**BEFORE THE WASHINGTON
UTILITIES AND TRANSPORTATION COMMISSION**

DOCKET UG-240008

KONSTANTINE GERANIOS

Analysis of South Kennewick Gate and North Kitsap Lateral

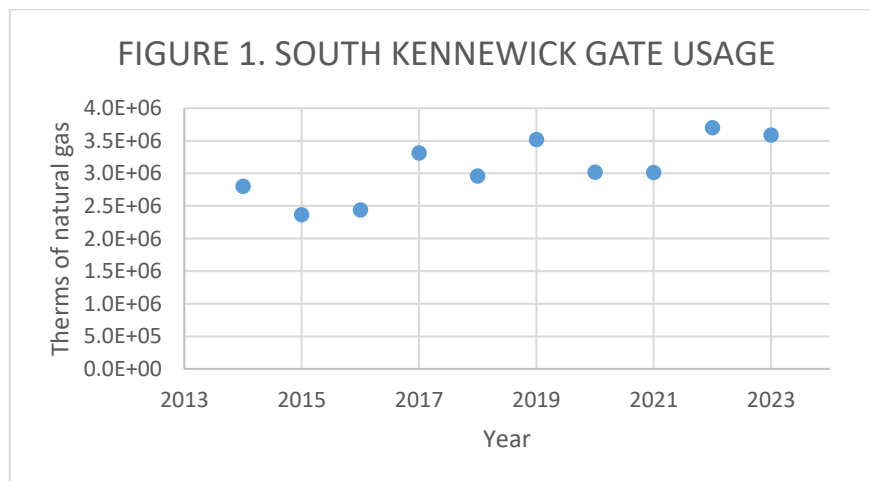
5 A. The Company forecasts 2.38 percent annual load growth on the Kennewick loop.
6 The load growth was largely increasing until around 2017, but Company data
7 indicates that growth has slowed as can be seen in Figure 1 below.¹⁵ From 2019 to
8 2022, the overall growth in natural gas usage was 5.17 percent, significantly less
9 than the Company's projection of 7.31 percent over those three years, as can be seen
10 in Figure 1. The growth between 2019 and 2023 was even less, at 1.9 percent, much
11 less than the forecasted 9.87 percent. Staff asserts that state mandates, federal
12 incentives, and consumer choice will continue to reduce natural gas use below the
13 Company's forecasts in the coming years. This does not support the need for more
14 capacity as stated by the Company.
